UNITED STATES PATENT AND TRADEMARK OFFICE

APPLICATION NO.	FILING DATE	FIRST NAMED INVENTOR	ATTORNEY DOCKET NO.	CONFIRMATION NO.
10/681,472	10/08/2003	Craig A. Urman	FLAPA.001CPI	7873

Office Action Summary

FIG. 2

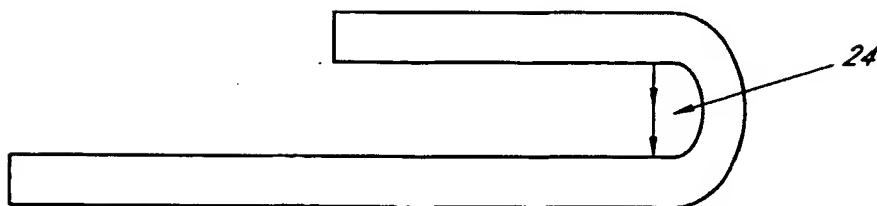
not approved

FIG. 4

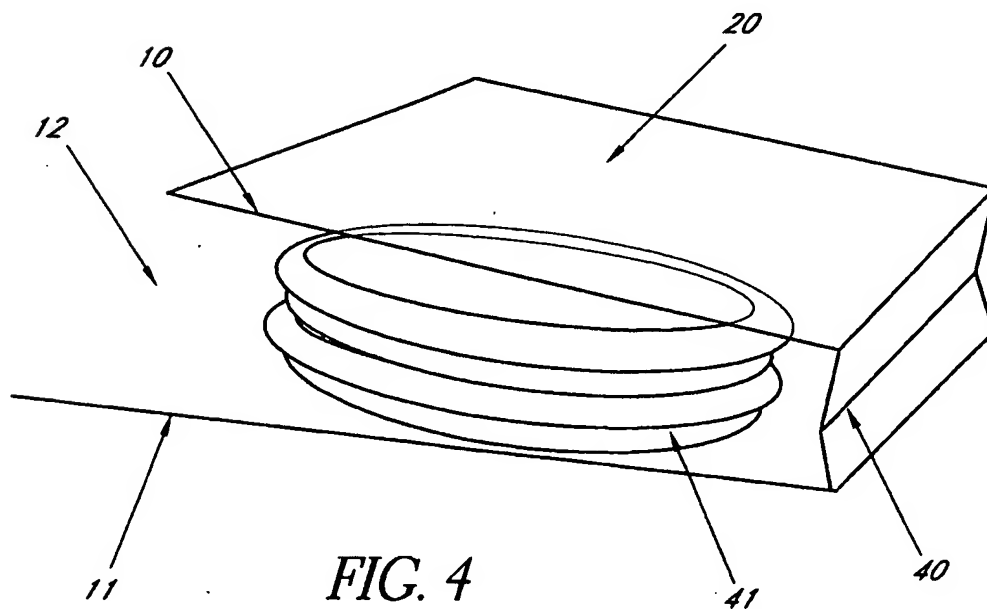
2. The drawings were received on August 9, 2006. These drawings are approved in part. Replacement sheets 1 and 4 are approved, while replacement sheets 2 and 3 are not. Replacement drawing figure 4 eliminates the handle and figure 5 inserts lines purported to represent the handle. These figures are not approved as they are not supported by the original disclosure.

not approved
yet
